RECORDS OF THE GOVERNMENT OF INDIA,
PUBLIC WORKS DEPARTMENT.

No. CCVI.

INSTRUCTION OF THE MADRAS HARBOUR.

1885.

12. The section I would propose is this—

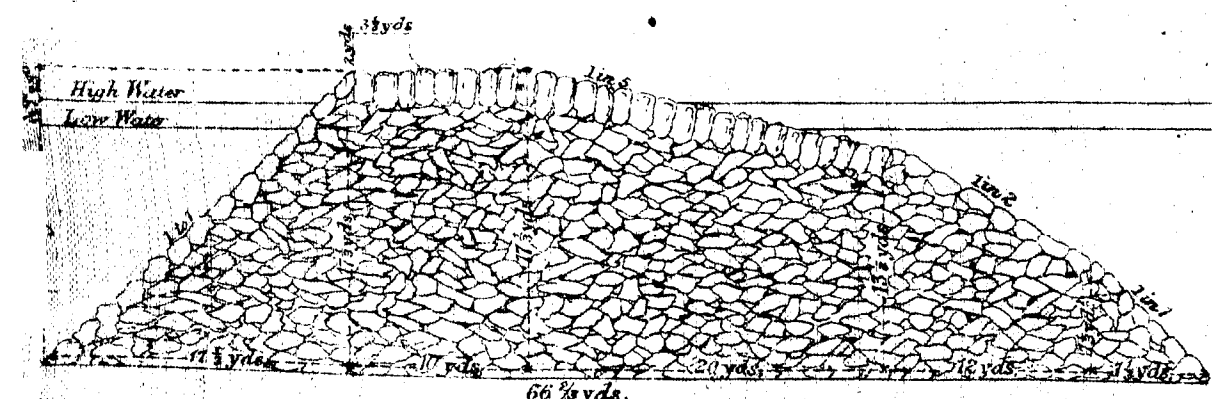
Sectional Area of rubble $781\frac{1}{2}$ yds.

13. It differs from Mr. deClosset's only in being suitable for a break-water in seven fathoms at low tide instead of at high tide, in having its sea slope carried down to low water instead of to 15 feet below that level, and in having its crest a few feet higher than Mr. deClosset's seems to think necessary.

16. A reference to my section will show that I would make the top of the break-water 30 feet broad, and base it 6 feet above high water. This would give solidity, as well as great stability, and probably afford quite sufficient protection to the anchorage. If, however, the sea were found to wash over the crest to such an extent as inconveniently to disturb the anchorage, a sea wall in the position denoted by dotted lines might be added without difficulty. Constructed as I propose, the break-water, if stone in sufficiently large blocks be used, would probably occupy a base of 662½ yards, and contain 781 cubic yards of stone for every running yard of its length, or 1,562,000 cubic yards in all. This is an enormous quantity of material, but it may perhaps be reduced by the judicious disposal of the large and small stone, the former being deposited on the outer slope and crest, and the latter all on the inner side, and as a core to the mass. The stone, as thrown in at random within the space marked out for the break-water, would probably stand at a slope of 45°, or one of base to one of height to near the level of the low water. From that point upwards the stones, in whatever manner they may be thrown down, will begin to assume for themselves under the action of the waves a long slope to seaward, and it will only then be necessary, as the work approaches the surface, to be careful to throw in all the largest stone on the outer side of the work, and all the smaller on the inner. The sea will arrange them of itself in the manner best adapted to resist its force, and the work may be brought gradually into shape by the judicious use of large or small stone as occasion may require. Ultimately, after the work has taken a permanent form, its surface may be finished off with a covering of large stones carefully packed on end.

14. This is Mr. deClosset's section—

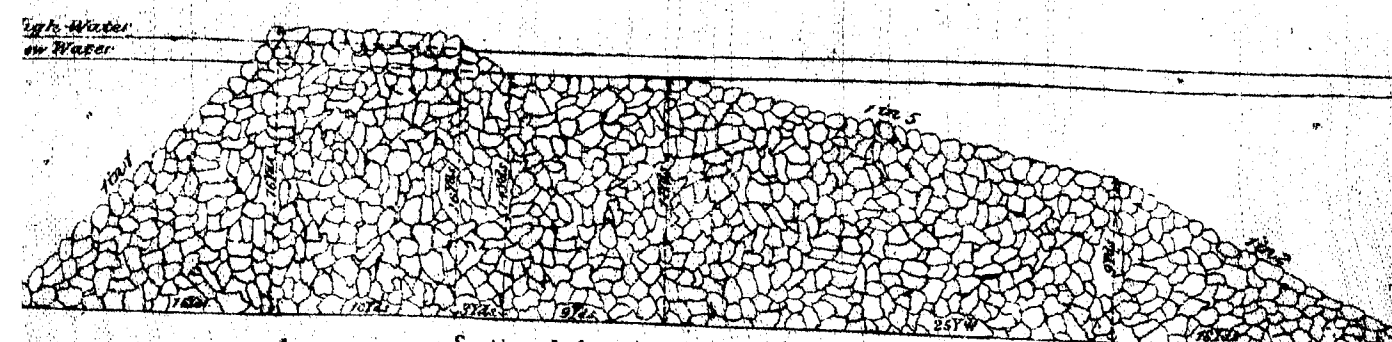
Sectional Area of rubble $82\frac{1}{2}$ yds.

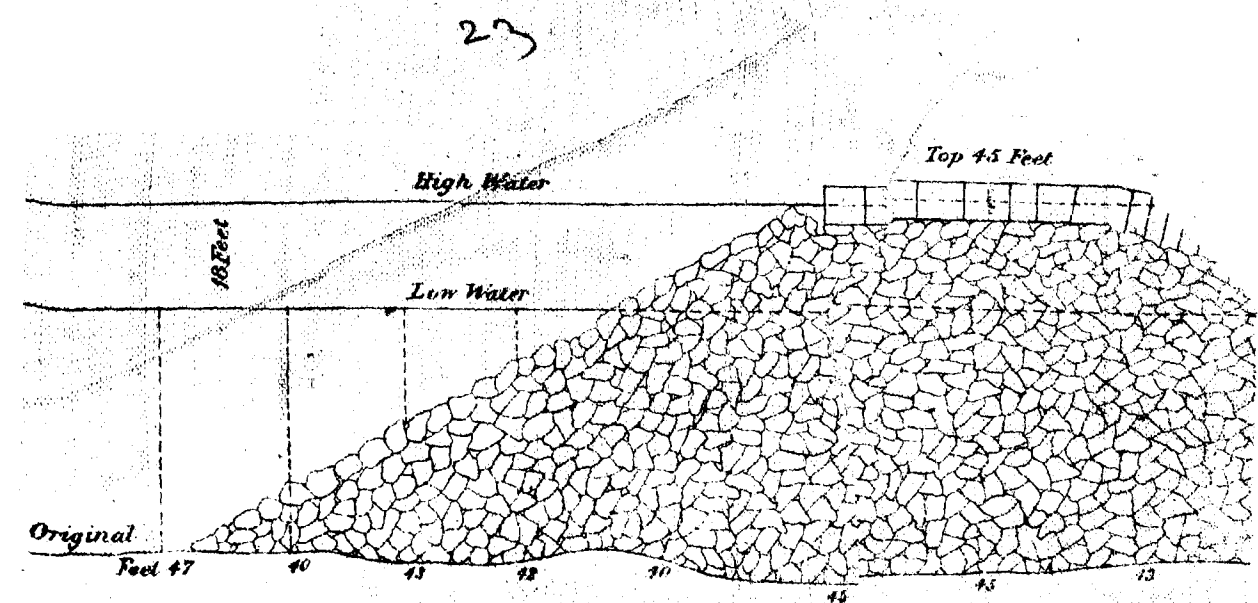
9. Mr. Robertson takes as his model the Portland break-water, which is a mere mound of rubble-stone which the sea has been allowed to wash down till the slopes have become permanent. Taking a mound of such a form and dimensions, calculating the quantity of stone required for its formation, and dividing this quantity into the estimated cost, I find that Mr. Robertson has assumed that the stone will cost (including staging, pier from shore, and, I presume, circular heads of masonry, but exclusive of the 15 per cent.) about R8 per ton.

10. Now, I readily admit that the Portland break-water is a noble and successful work, and that it might be a proper model for another break-water, if such had to be constructed under similar conditions. But I unhesitatingly deny that it is a proper model to adopt under conditions so different as are those of Madras. The stone at Portland cost, I believe, about R2 per ton, instead of R8, as estimated at Madras. Do the resources of engineering science suggest no means of modifying the form of structure, so that the total cost may not also be quadrupled?

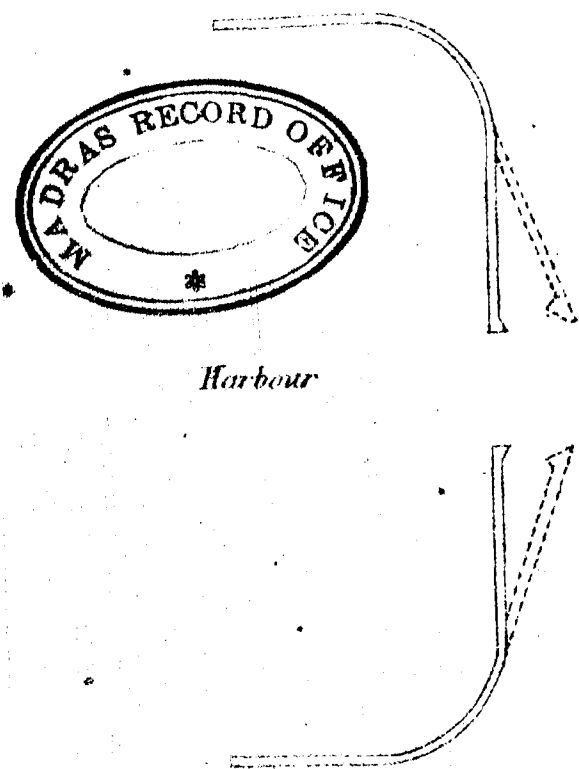
21. The first of these is the form of the seaward side of the harbour and the entrance. This is a question which I have always looked upon as desirable to be kept open till near the time when a final decision was necessary, and in the interim I have availed myself of such opportunities as presented themselves for collecting evidence as to the merits of different forms.

22. The result is that I am rather disposed to favour a change of the design to the form shown in red on the accompanying tracing and by dotted lines in the marginal sketch. The main argument in favour of the originally proposed straight eastern front is that if the present harbour should be followed by a series of similar basins ranged along the coast, a series of re-entering angles would be formed in which converging waves would be concentrated to an inconvenient extent. On the other hand, the projecting entrance, though more in accordance with precedent, and undoubtedly more convenient for the entrance of vessels under sail, did not appear to have so much superiority for steamers.

23. I find, however, that Commanders of steamers would generally prefer the projecting entrance as leading the cross current off from acting on the after part of a long ship, while the fore part is in still water and with little way on her; also, it would give a greater space to bring up in without danger of fouling ships at moorings. Captain Taylor, the Master Attendant, prefers this form.

DIAGRAM No II.

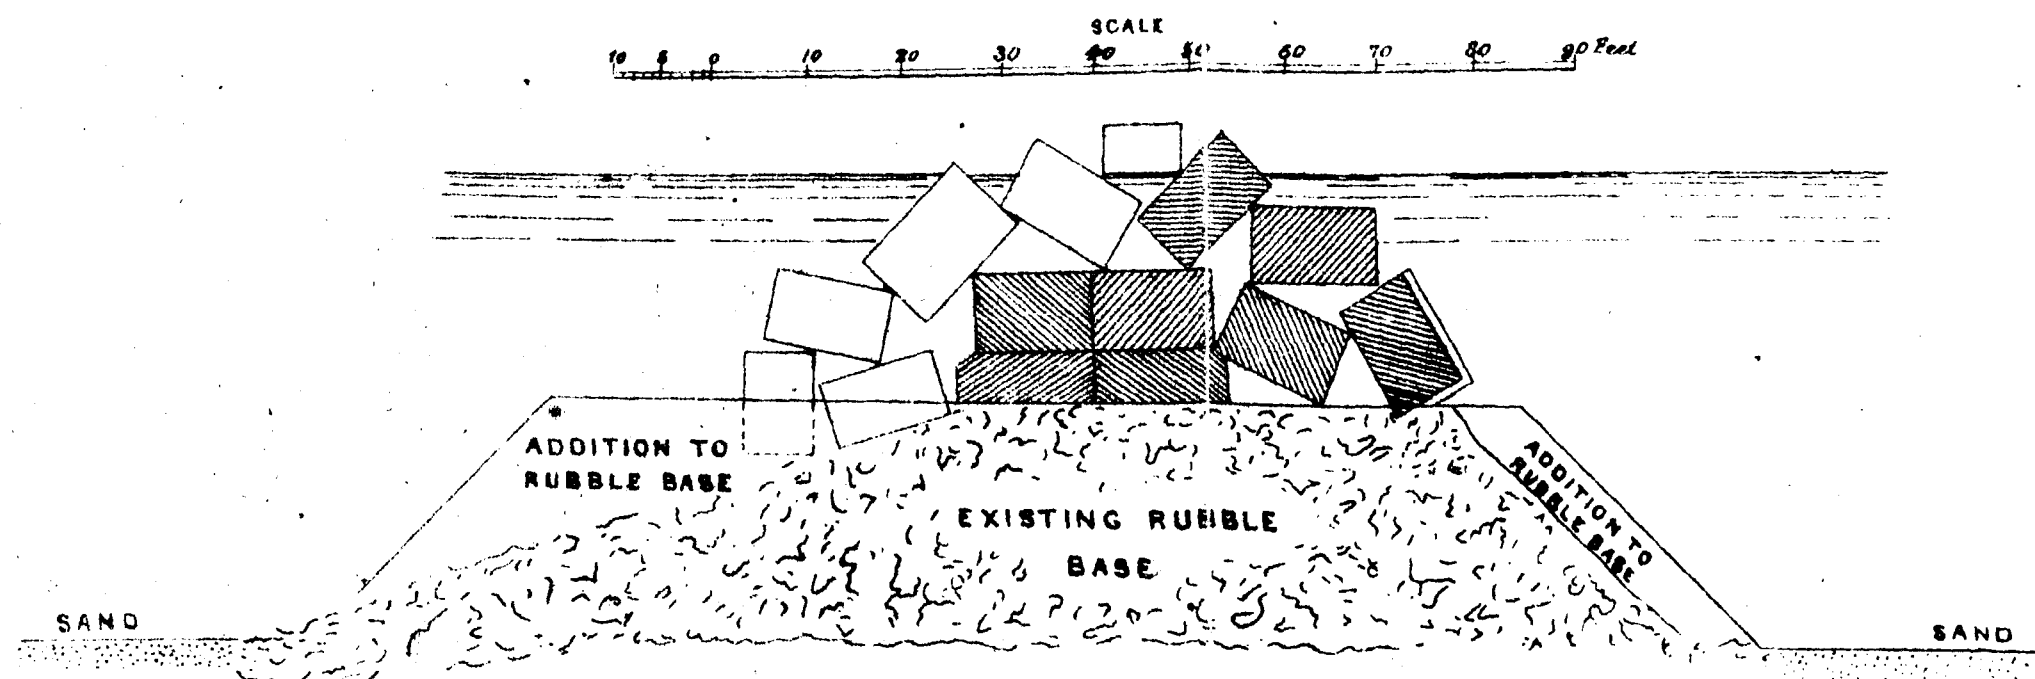
PROPOSED TYPICAL SECTION FOR RECONSTRUCTION

ADDITIONAL NUMBER OF BLOCKS IN TYPE SECTION = $4 \frac{1}{2}$

DIAGRAM № 3.

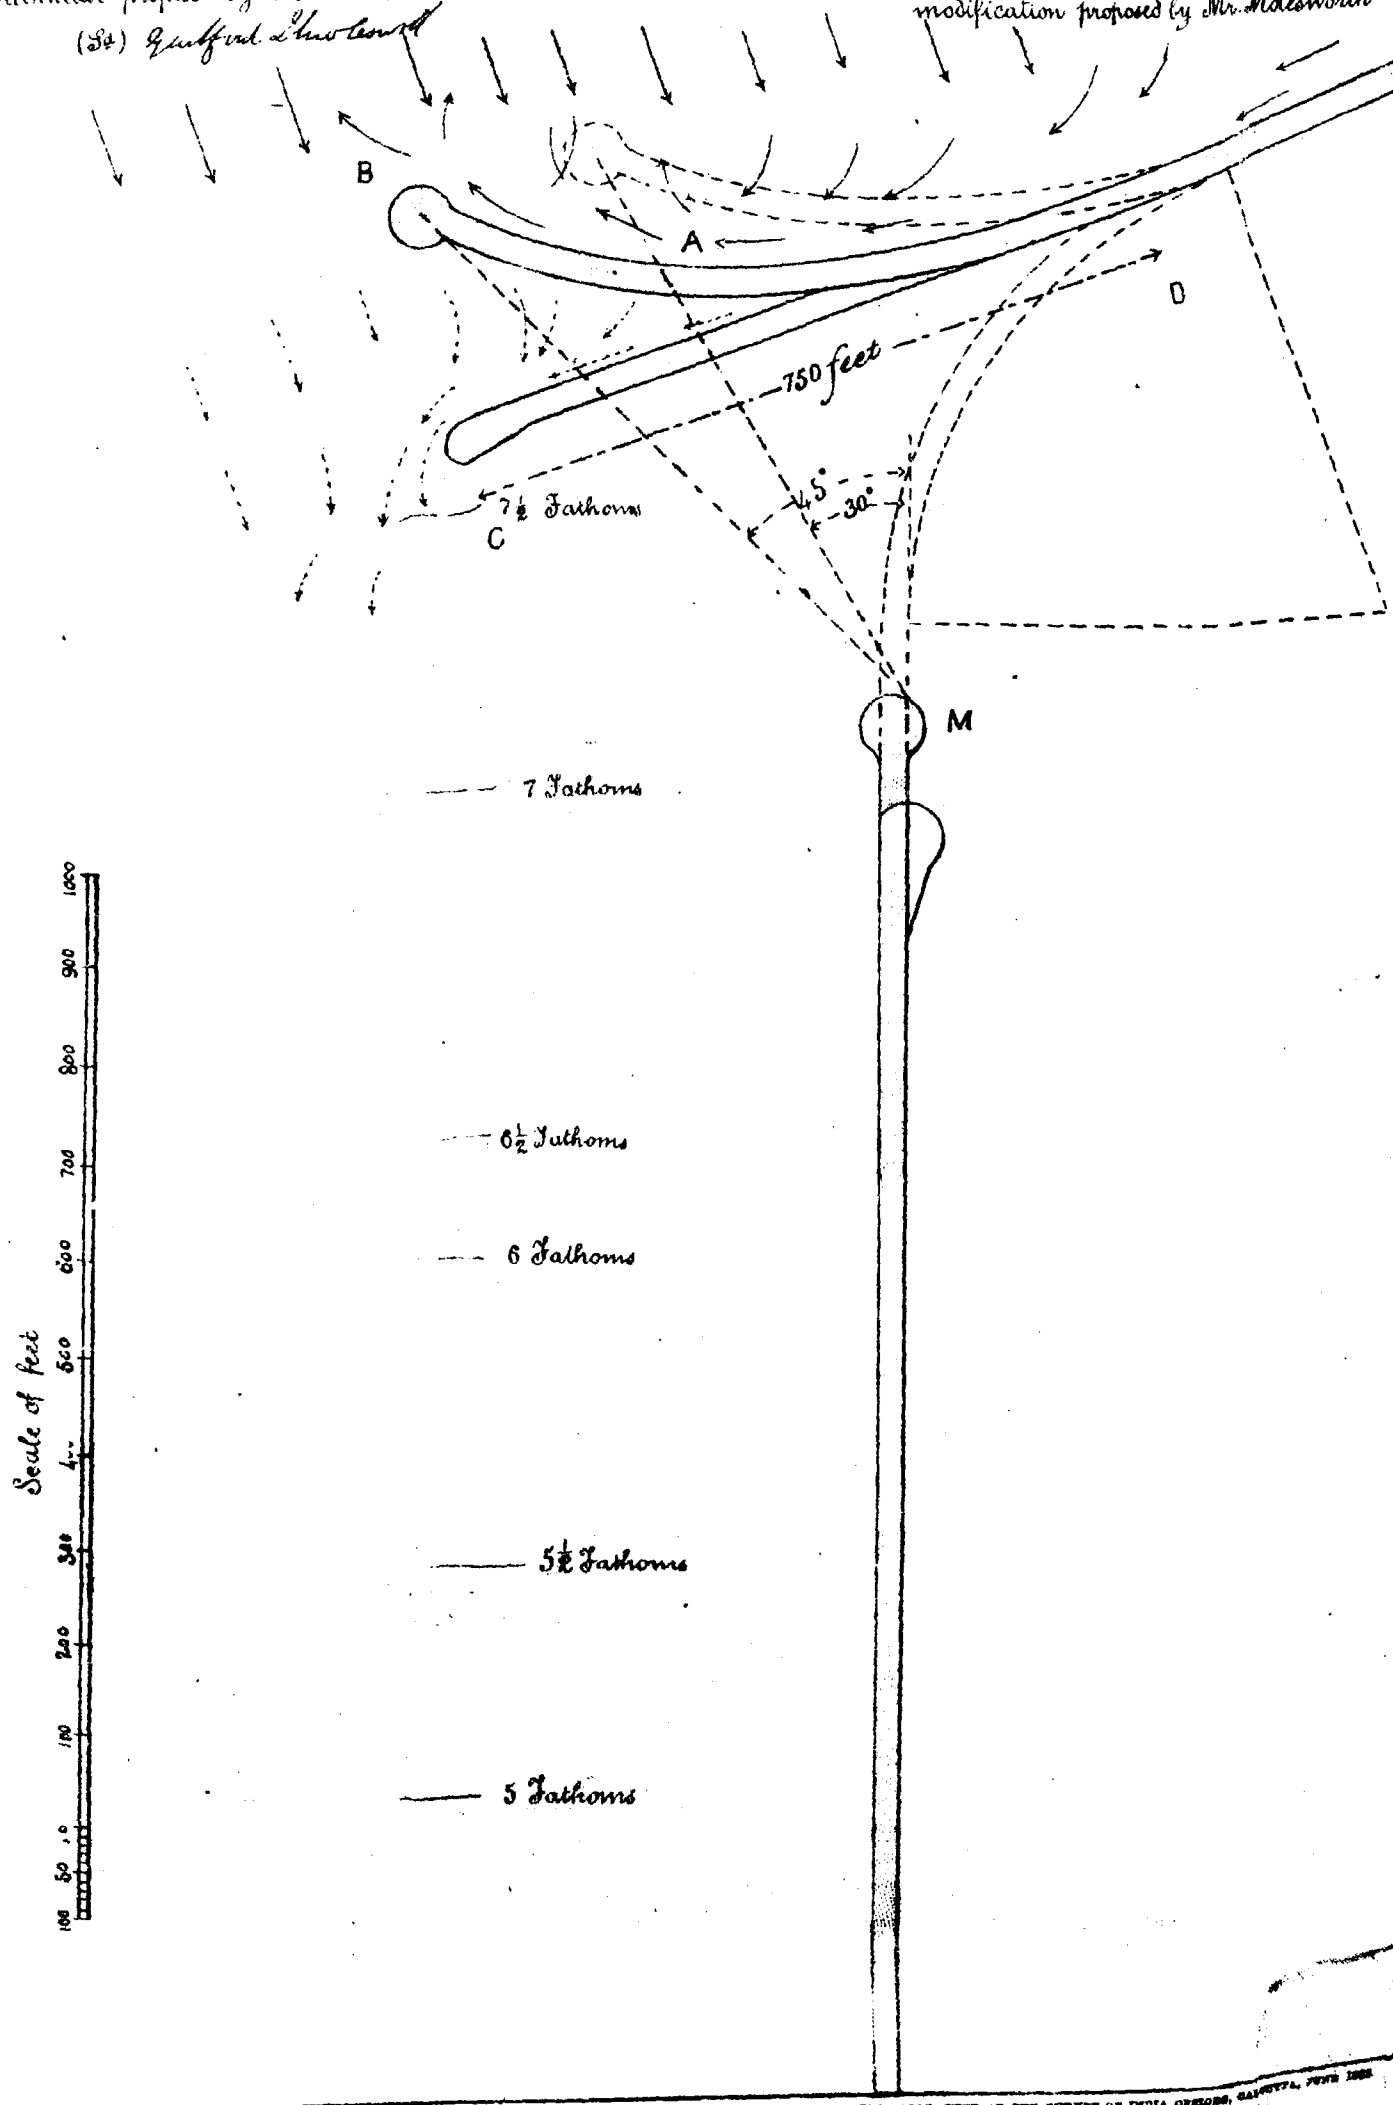
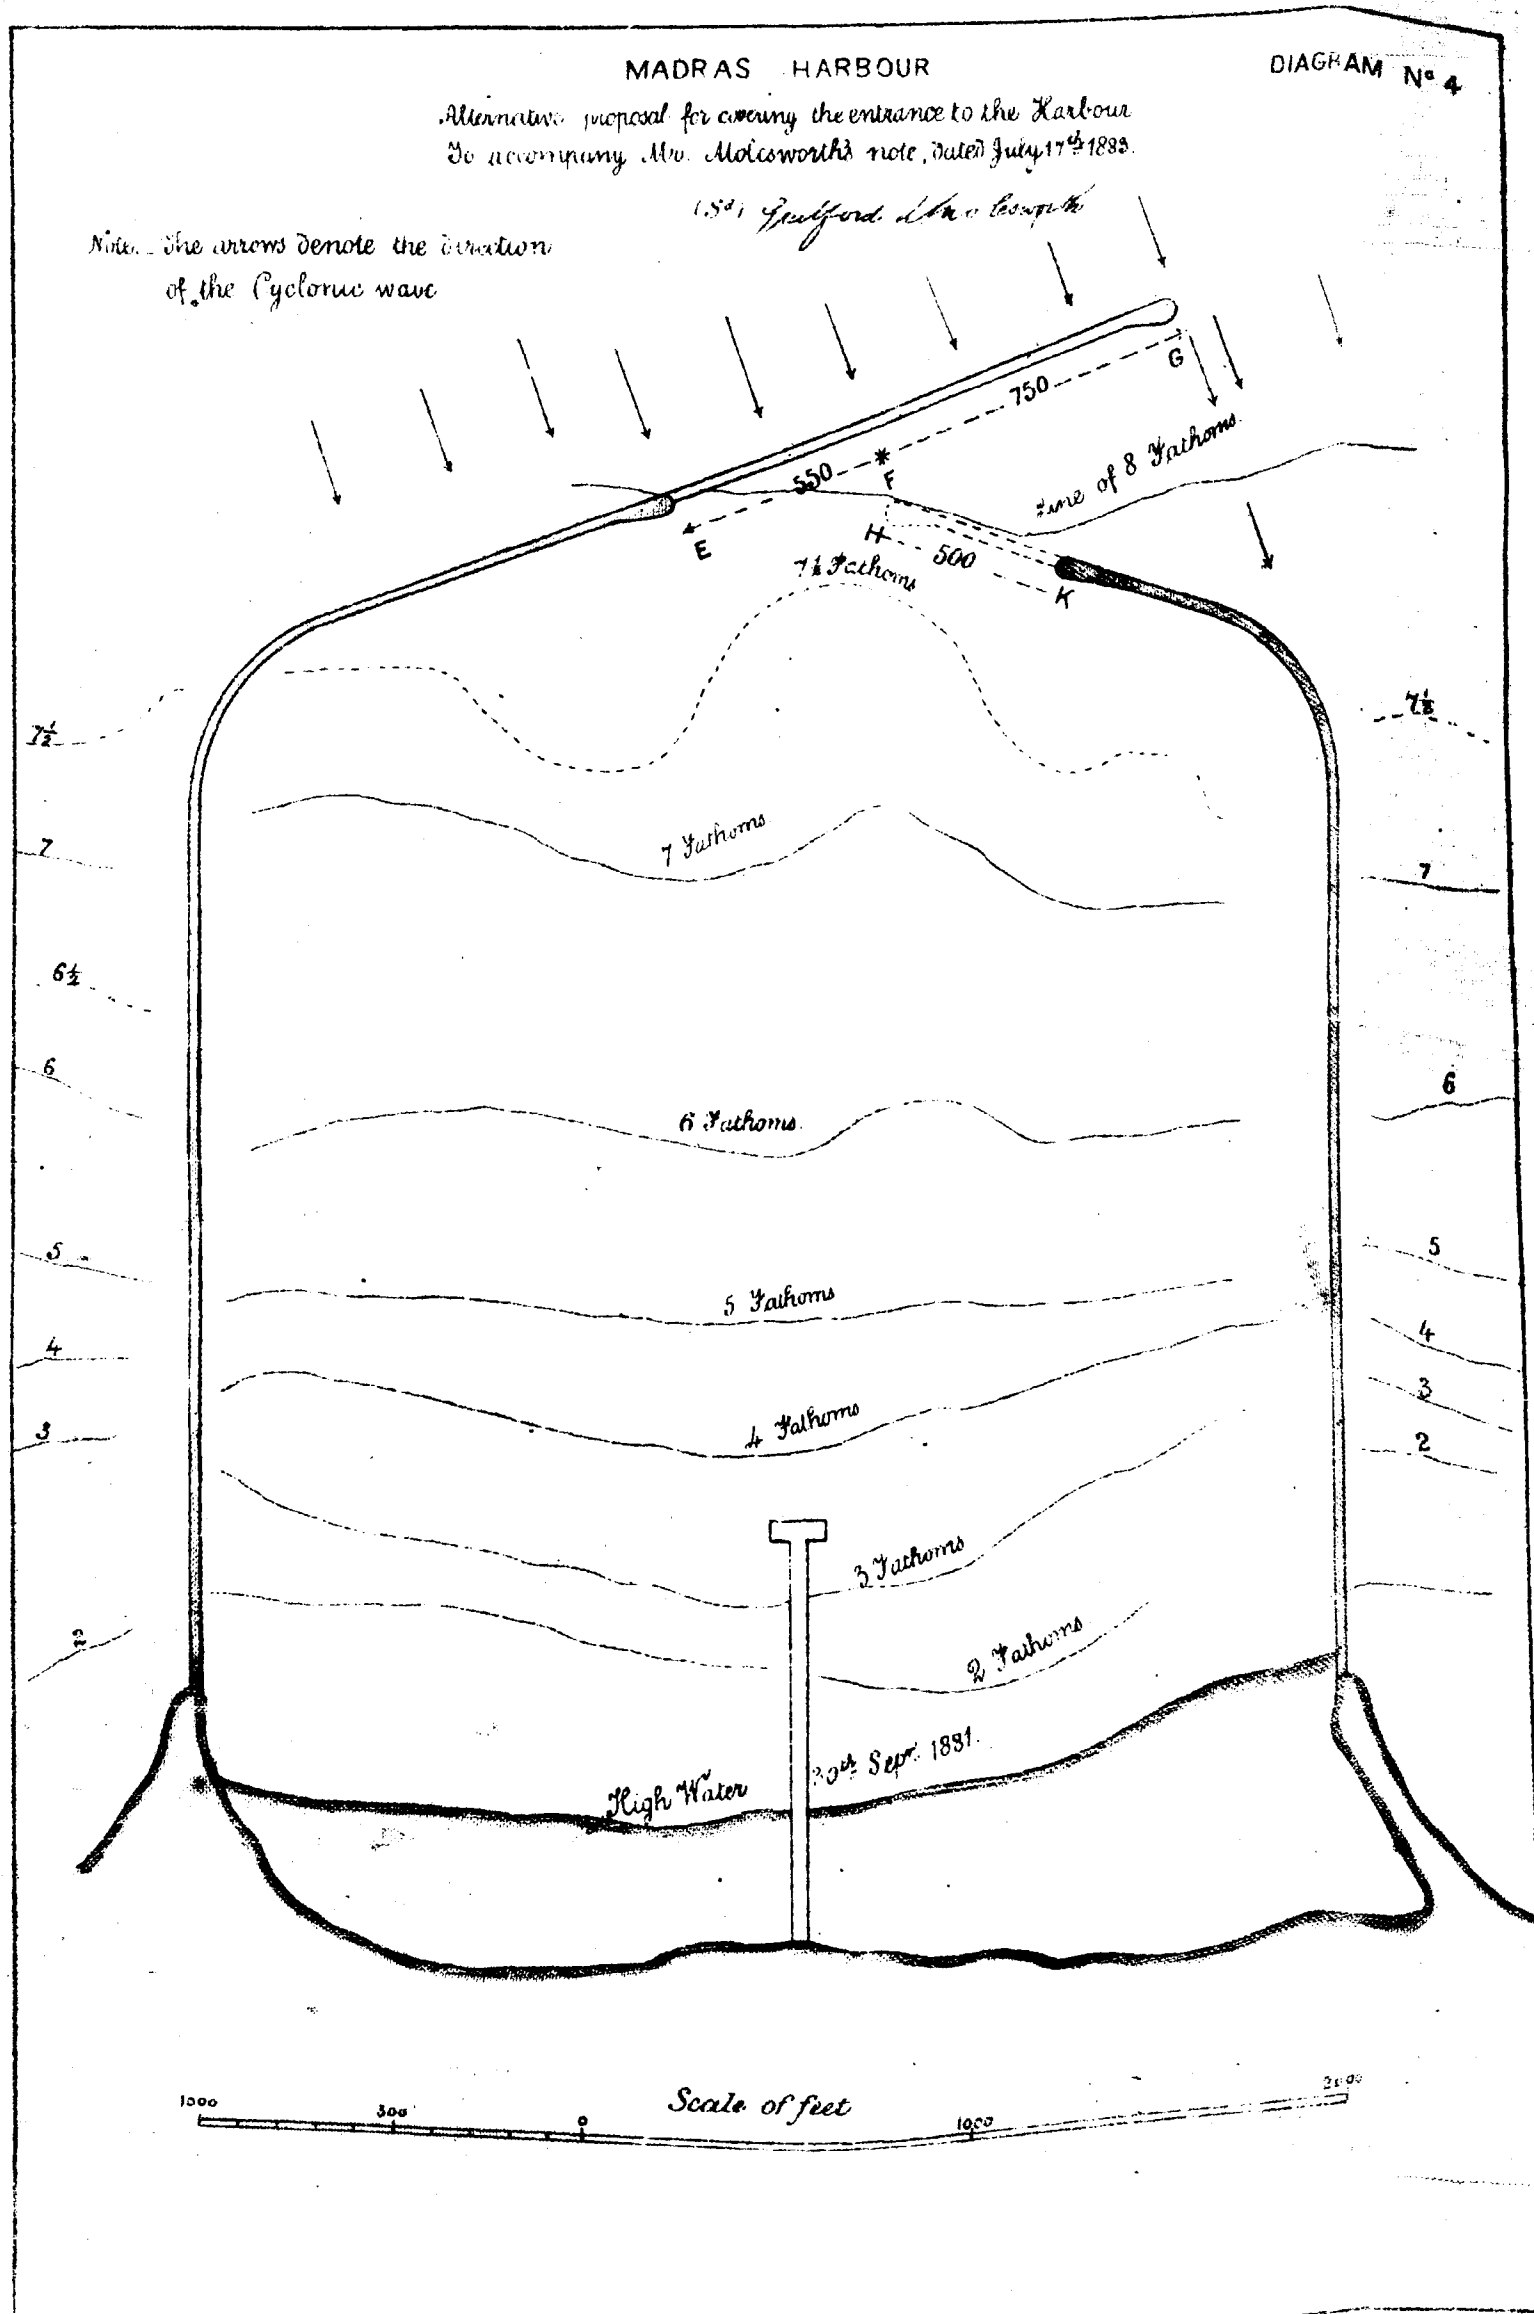
Note The dotted lines show the freshwater as proposed by the Madras Committee. The portions coloured black show the increased length suggested by Col. Trevor. The portions coloured red show the modification proposed by Mr. Molesworth.
